**THE STATE OF FLORIDA
DEPARTMENT OF ENVIRONMENTAL PROTECTION**

DEP File No. SC51-277316
Pasco County

INTENT TO ISSUE

The applicant, Pasco County Board of County Commissioners, applied on September 11, 1995 to the Department of Environmental Protection for a permit to construct a leachate storage tank and treatment facility adjacent to the existing Resource Recovery Facility, located near Hays Road, 2 miles north of S.R. 52, Springhill, Pasco County, Florida.

LEACHATE STORAGE TANK
LEAK DETECTION SYSTEMS

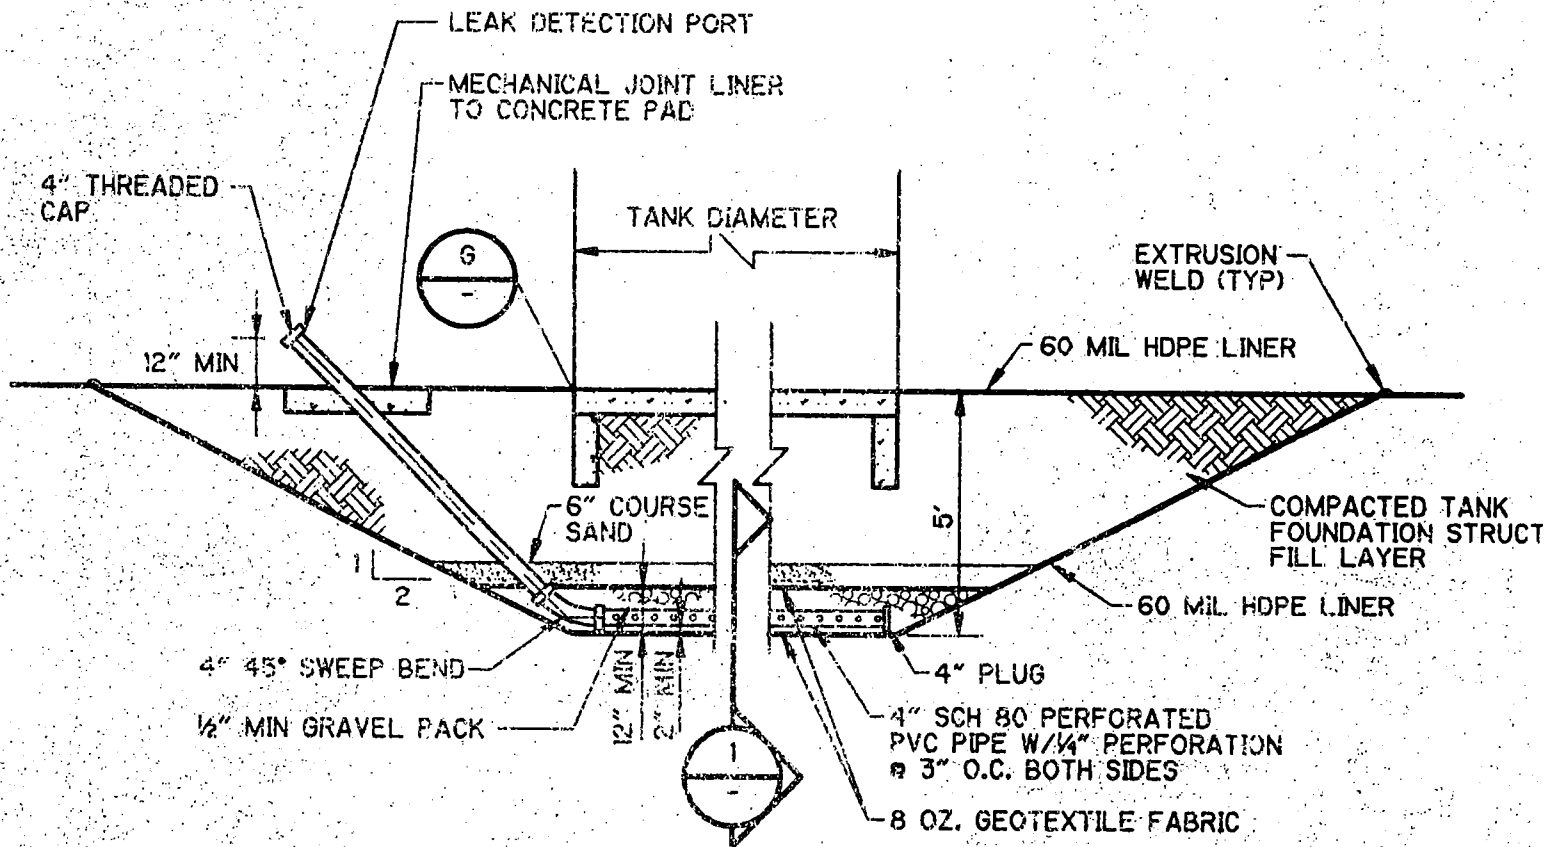
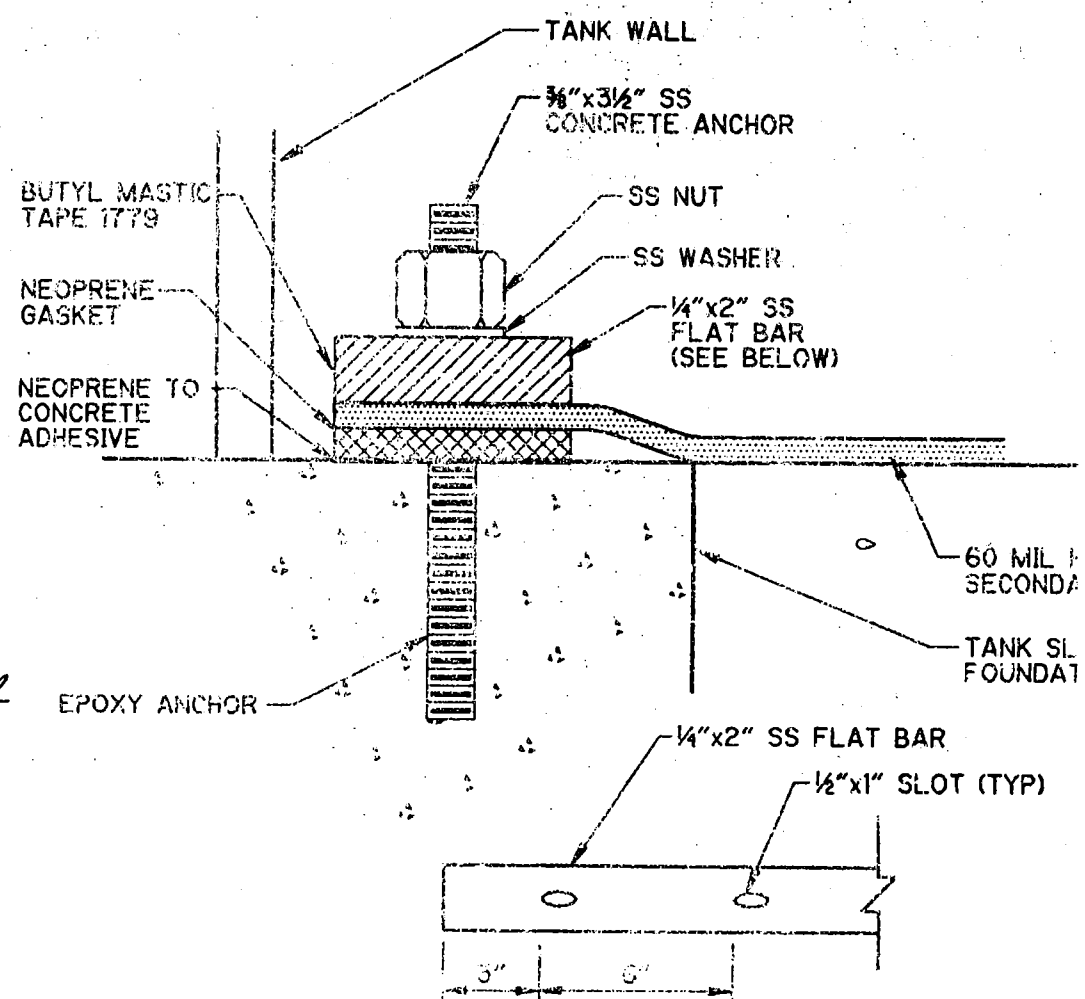
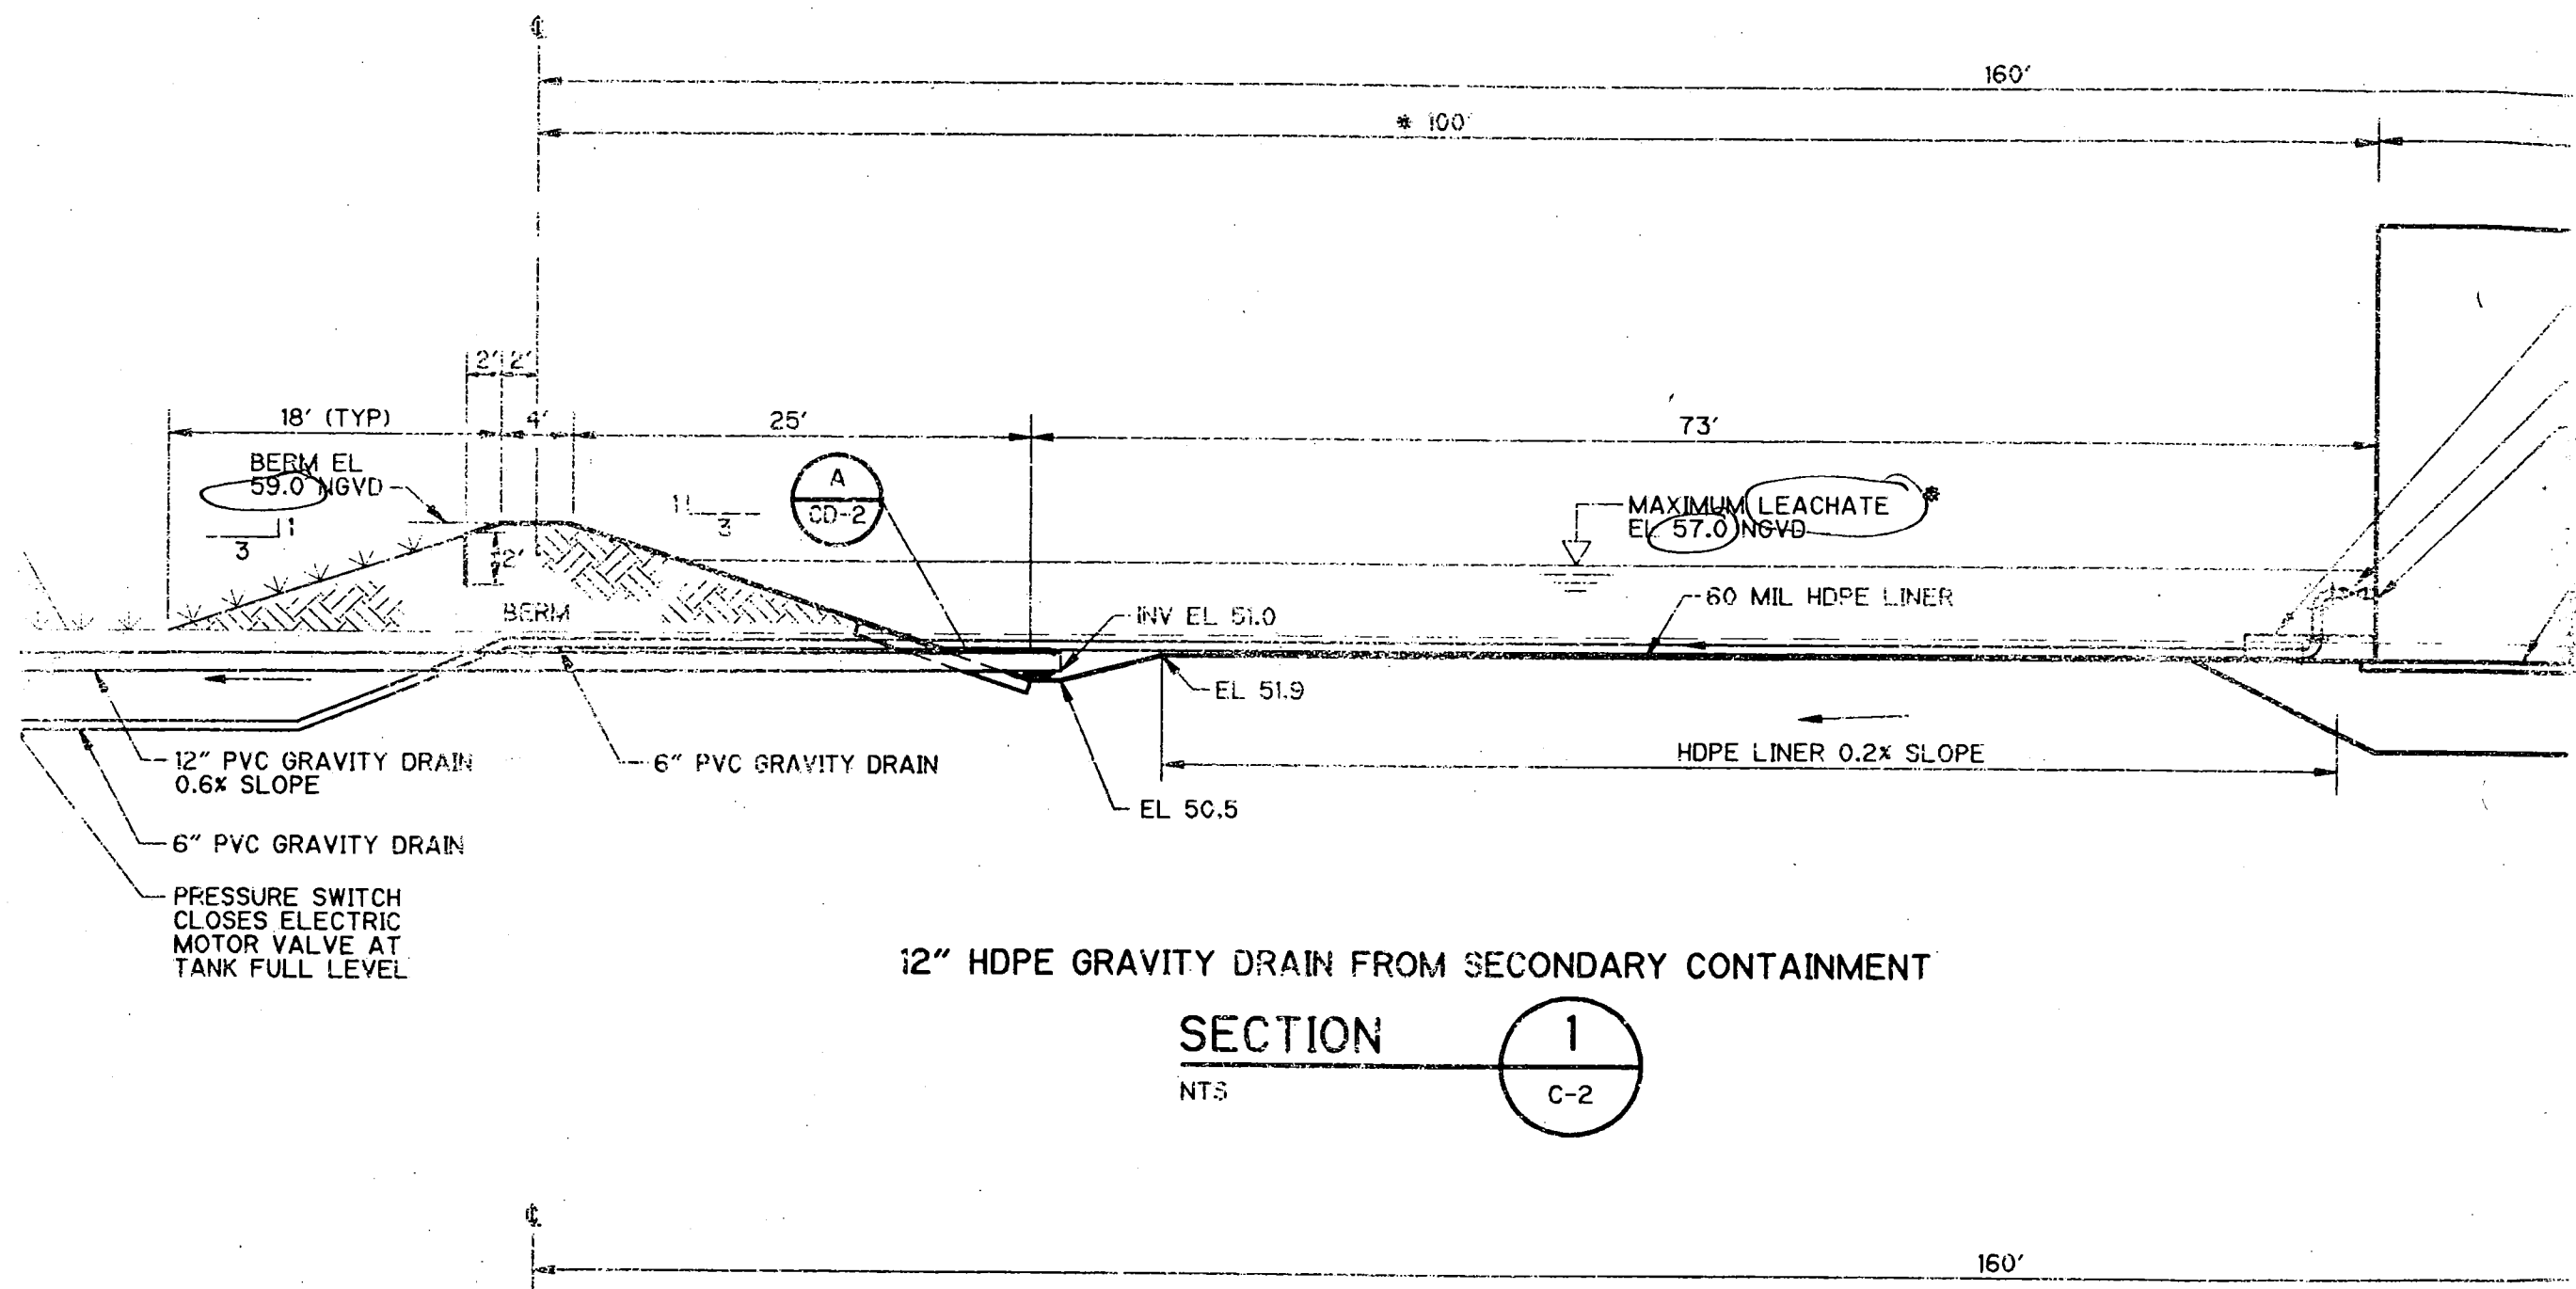
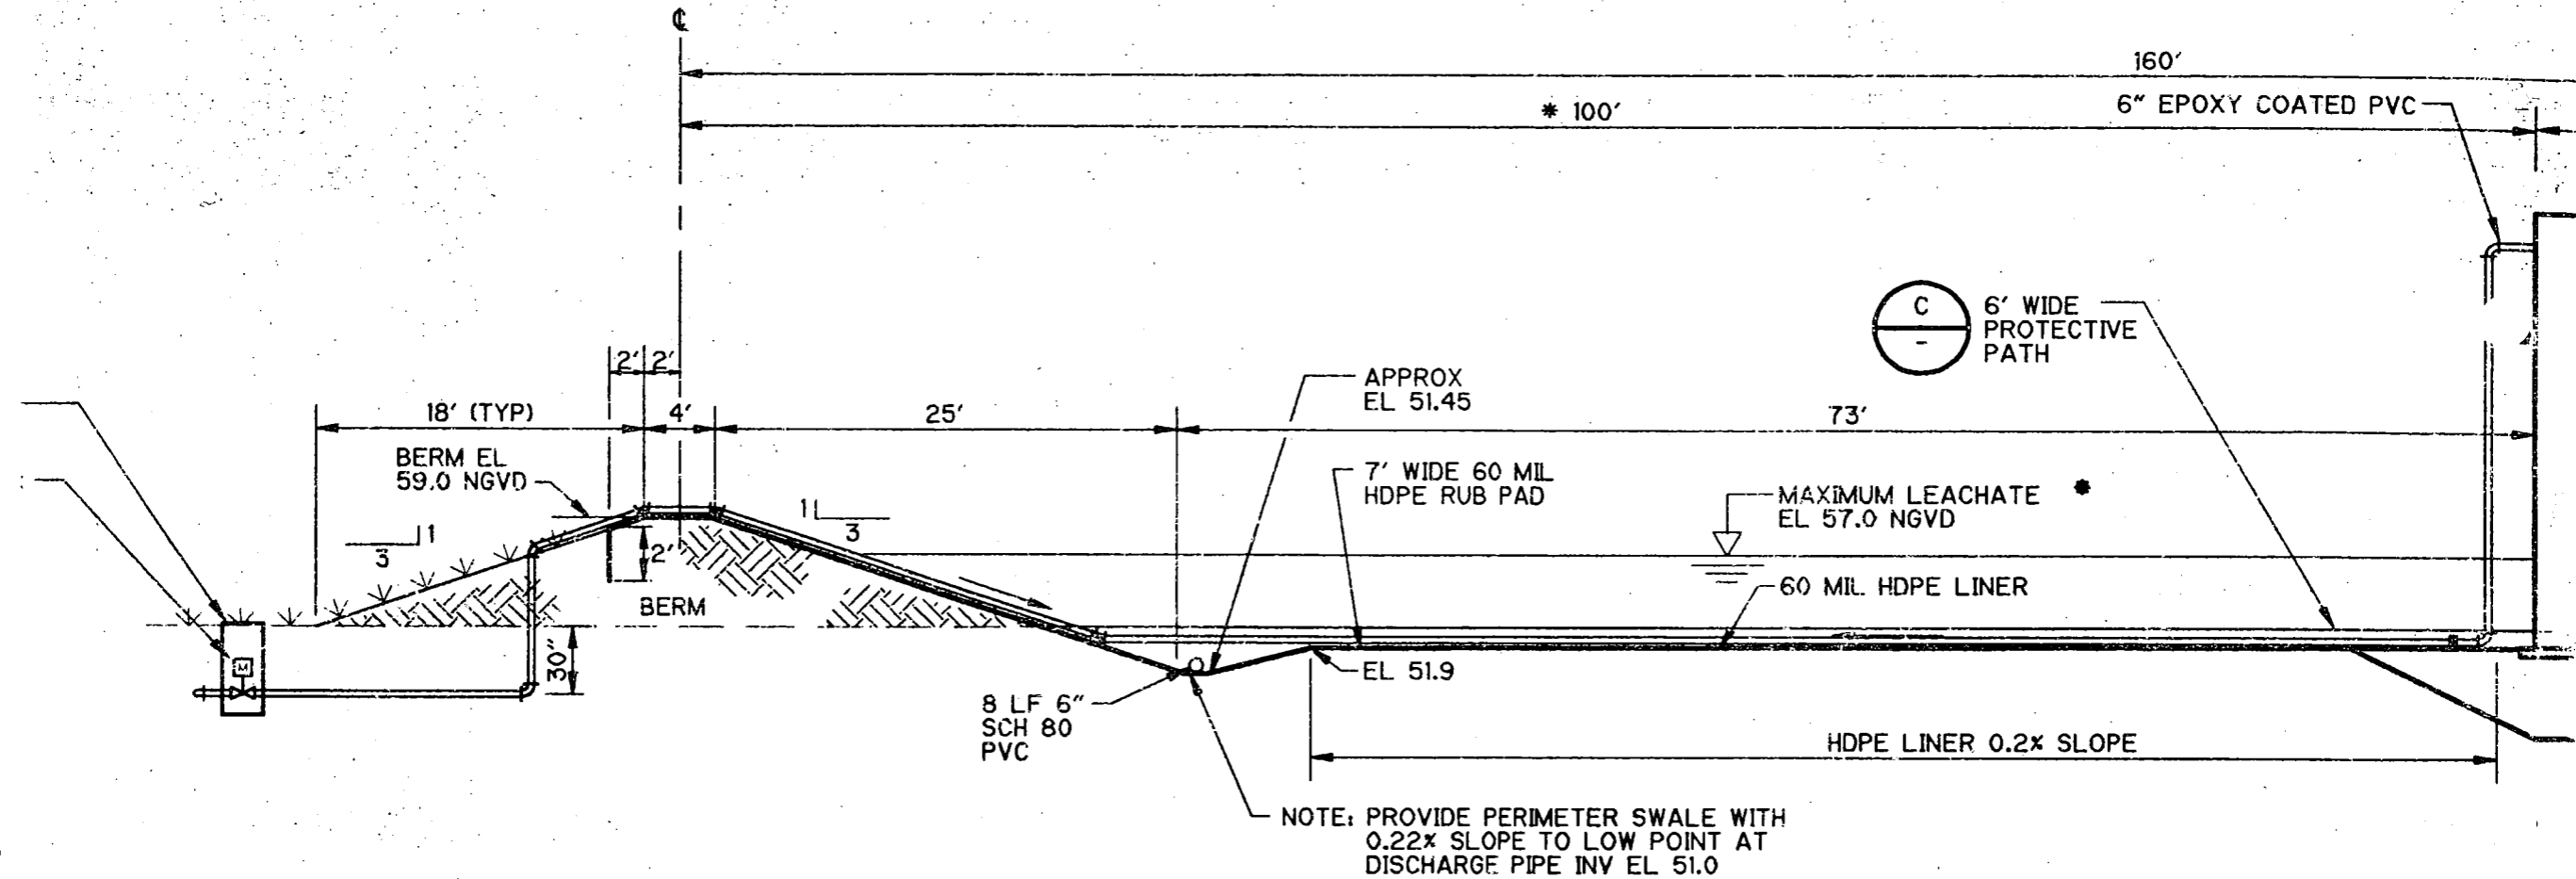
b. Sheet C-2. The elevation of the bottom of the tank does not appear to be shown. Section 3/CD-1 does not appear to be oriented correctly.

- 5) Detail A/CD-2. The pipe shown in this detail does not appear to correlate with other details. The reference for 6" or 12" should be clarified. Is the pipe HDPE or PVC? Detail C/CD-1 indicates a 6" PVC line, Sheet C-3 shows both a 6" and a 12" PVC line, and Detail A/CD-2 indicates a 6" or 12" HDPE pipe. Since a 6" PVC line will be connected to the penetration pipe, how will the HDPE pipe be connected to the PVC pipe?

d. Sheet CD-2. Detail F. It is not clear where this detail is referenced on Sheet CD-4.

- ✓e. Sheet CD-4. The dimensions of the concrete under the exterior ladder should be provided. How will the geomembrane be protected from this concrete slab?

Response: The drawings sheet CD-1, Sections 1 and 2, show elevation 57 as the "maximum leachate EL 57 NGVD*". The asterisk note states "in case of tank leak or overflow."

We will change the note to read "maximum leachate level for catastrophic full tank failure."

RESPONSE:

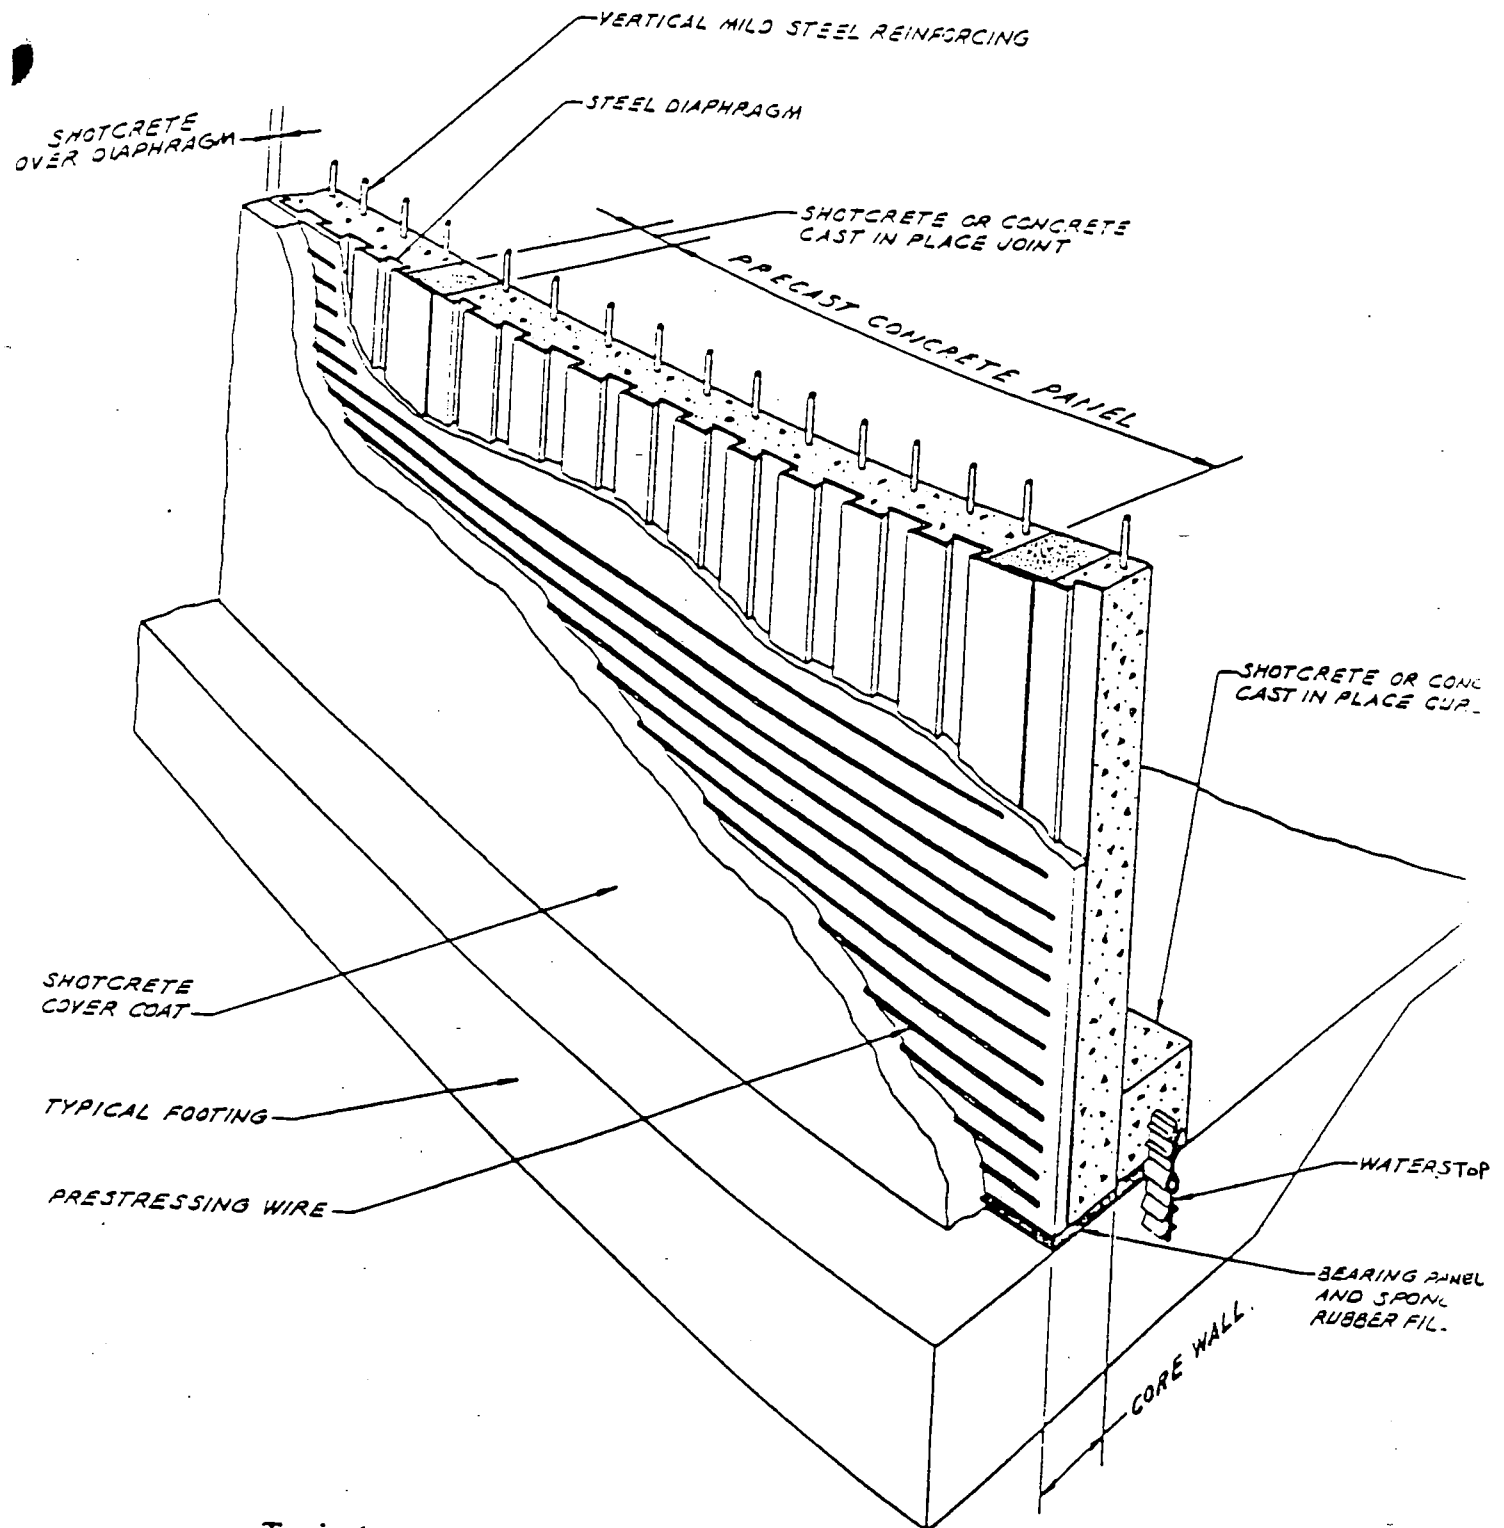
— impact
on permeability
??
WHY NOT
BIDDERABLE?

The solids handling bag material will be constructed of 3.0 ounce uncoated polypropylene material and 2 ply 6.0 mil polyethylene inner liner. A copy of the manufacturer catalog and price quote from a splicer are enclosed as attachment C. Also, a sample of the proposed bag material is enclosed. When filled with solids, each the bag will weigh approximately 5 tons. The solids handling bags will be placed in the landfill at the rate of about one per day. The bags will be initially placed on an area prepared for their placement. The area may be an unused portion of the cell or it may be on the ash residue where large metal objects have been removed. The bags will be placed side by side until it is reasonable to begin another lift.
